## **Proposal for Supplement 2 to the original series of amendments to UN Regulation No. 135 (Pole Side Impact (PSI))**

### **Submitted by the experts from the Working Party on Passive Safety\***

## Supplement 2 to the original series of amendments to UN Regulation No. 135 (Pole Side Impact (PSI))

**Figure**

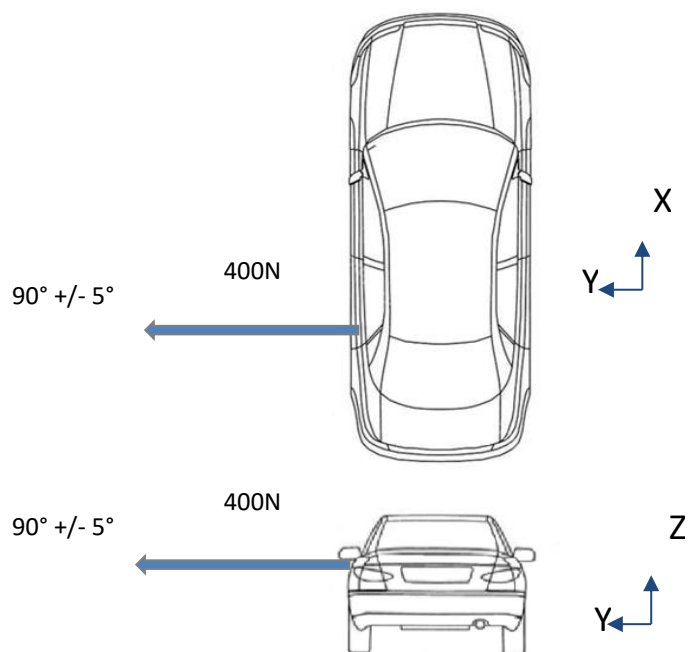
Paragraph 5.4.2.1, amend to read:

- "5.4.2.1. The door shall remain latched;  
 This requirement is deemed to be fulfilled:
- (a) if it is clearly visible, that the door lock is latched; or
  - (b) if the door does not open under a static tractive force of at least 400 N in the y-direction applied to the door, according to the Figure below, as close as possible to the window sill and to the edge of the door opposite to the hinged side, except to the door handle itself.
